CITY OF ALBUQUERQUE

Re: Murphy's Express, 2707 Carlisle Blvd. NE,

Request for Permanent C.O. –Accepted

Re: Murphy Express – 2707 Carlisle Blvd NE – Grading and Drainage Certification

STANDARD DETAIL
OIL/WATER SEPARATION SYSTEM
VORTCLAREX® VCL40

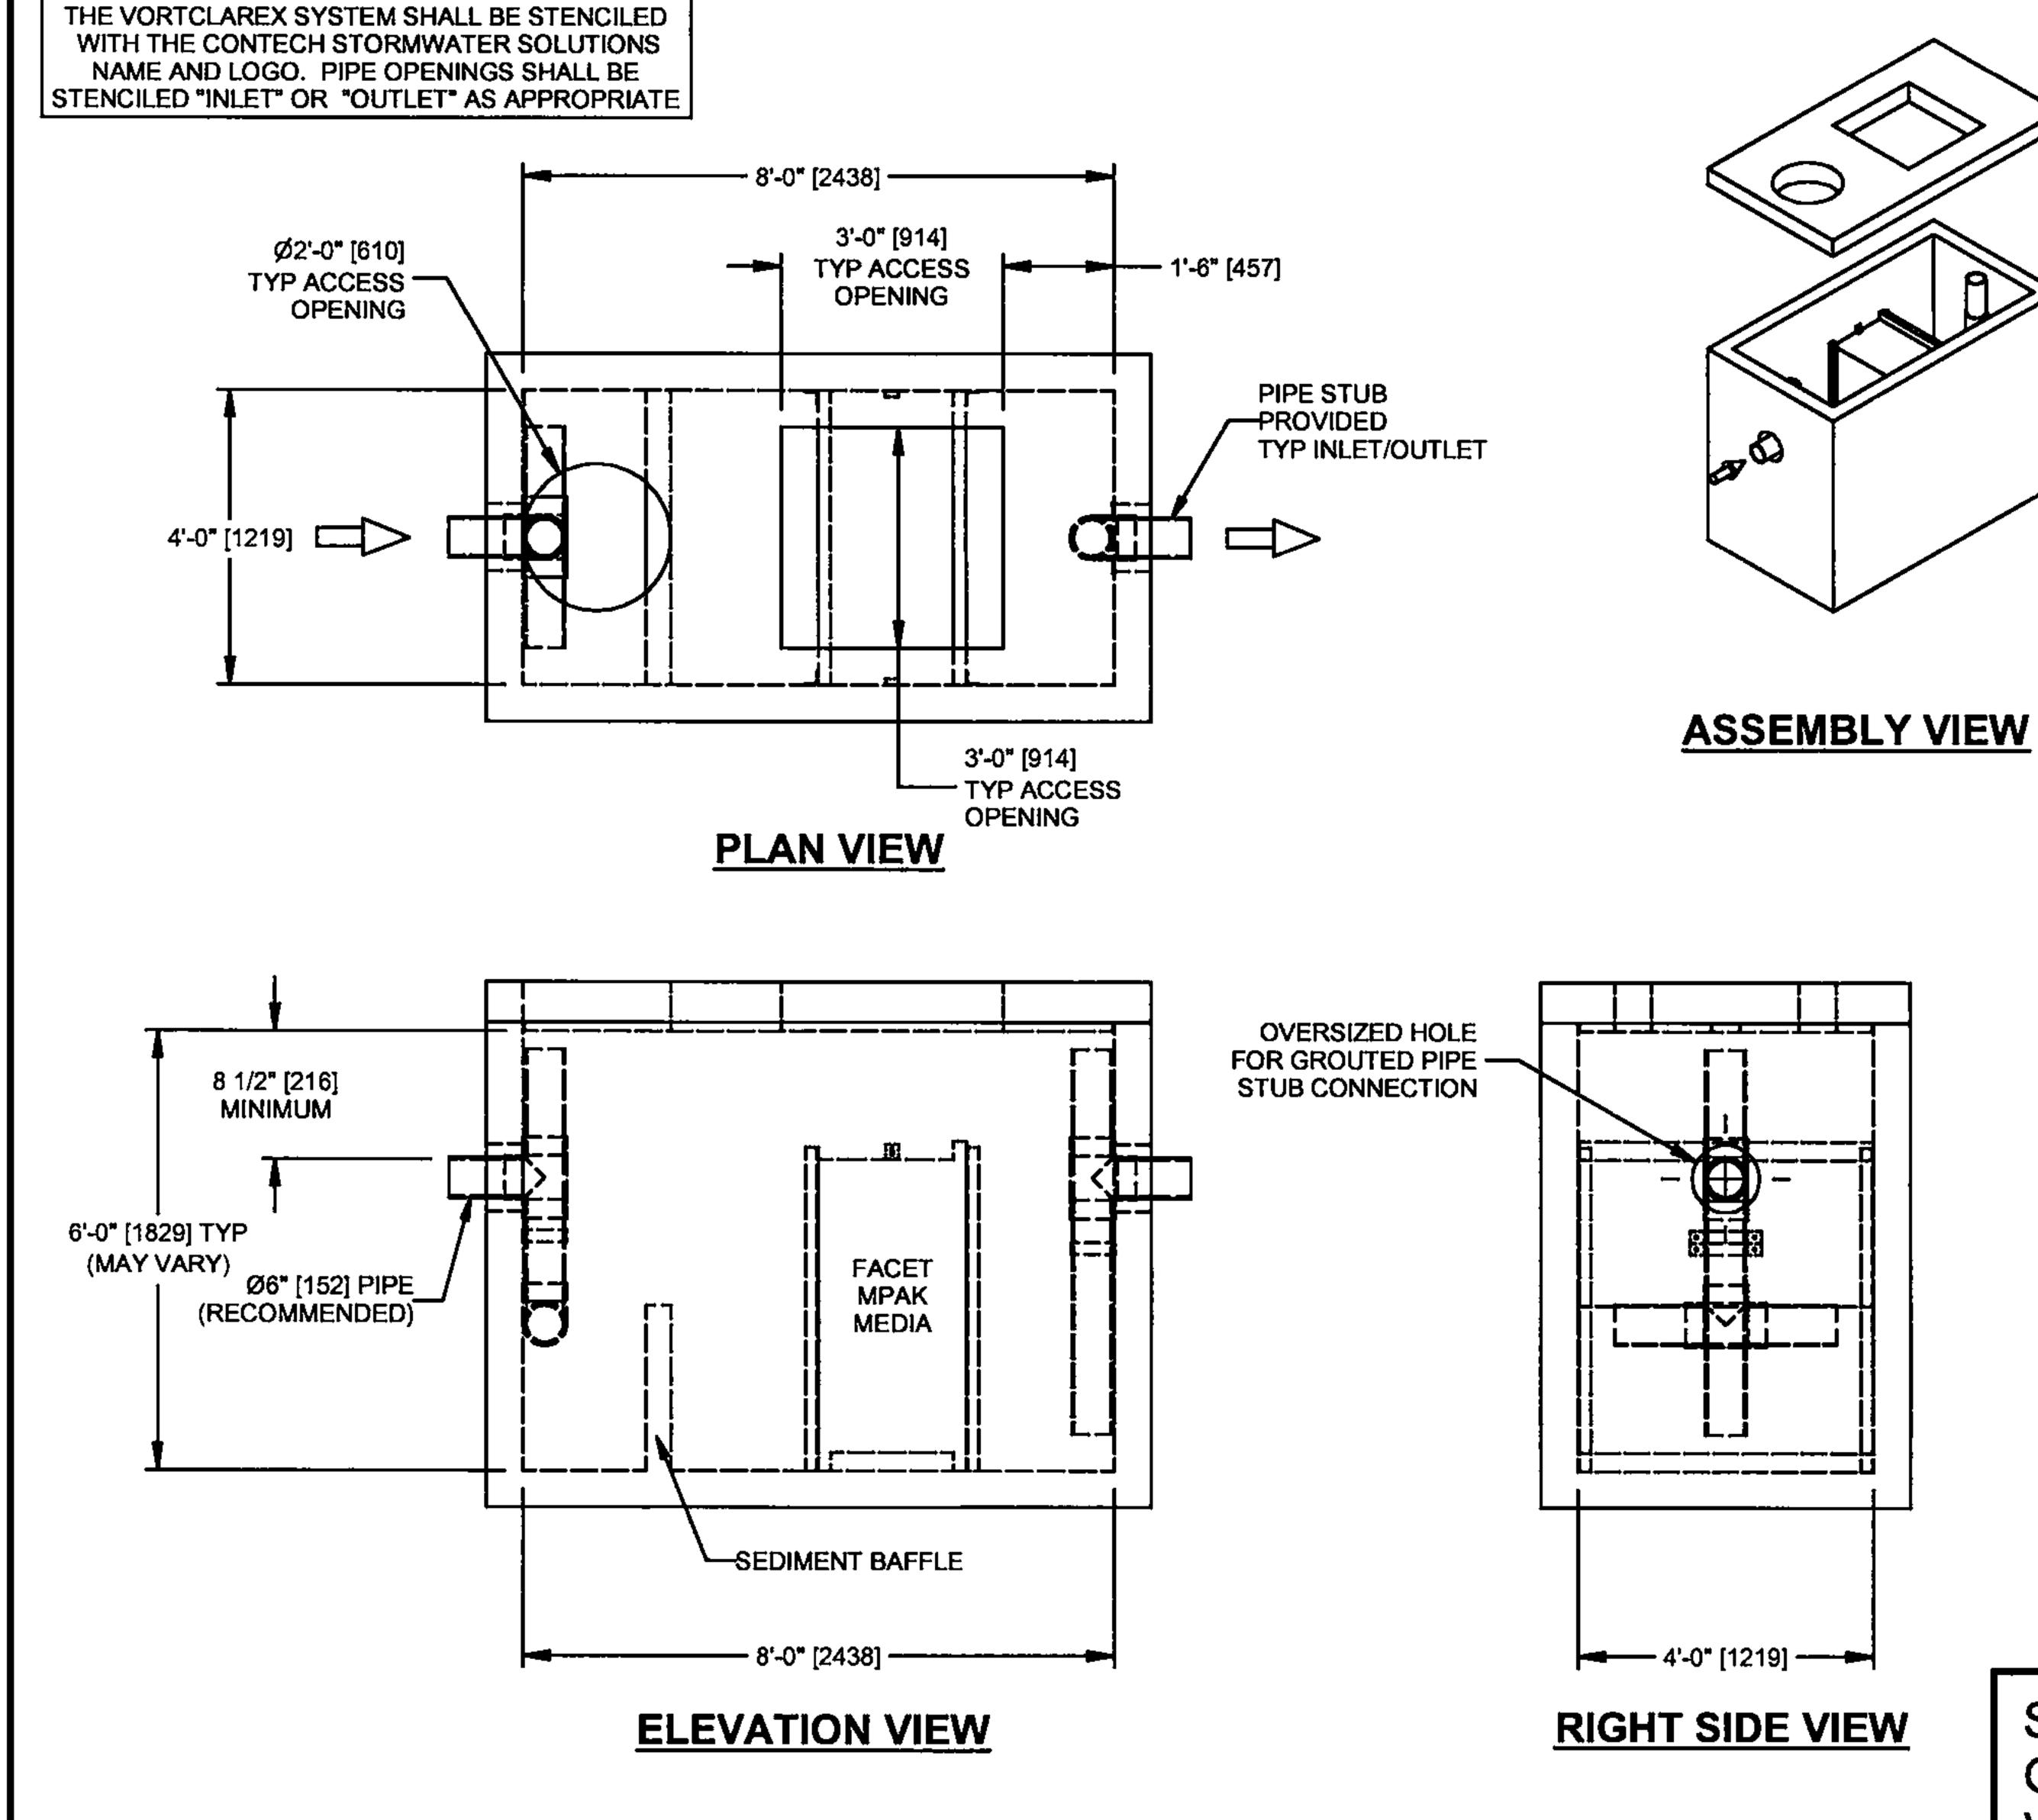
When submitting for Building Permit approval, please address the following comment: Hydrology has adopted a 500 gallon minimum oil/water separator standard based on input from consulting engineers. You have proposed a 320 gallon separator.

1. Hydrology has adopted a 500 gallon minimum oil/water separator standard based upon input from consulting engineers. You have proposed a 320 gallon separator.

Response: The anticipated 2-year runoff underneath the canopy is approximately of 0.3 cfs (134 gpm) (1.86cfs/ac * (7184sf/43560)). Research on various oil/water seperators led to the Contech VortClarex Oil/Water separator system. Model VCL40, with a capacity of approximately 900 gallons, can accommodate up to 150 gpm of inflow. This is what is now specified on the drainage drawings. Supplemental information on this system has been attached with the letter for reference.
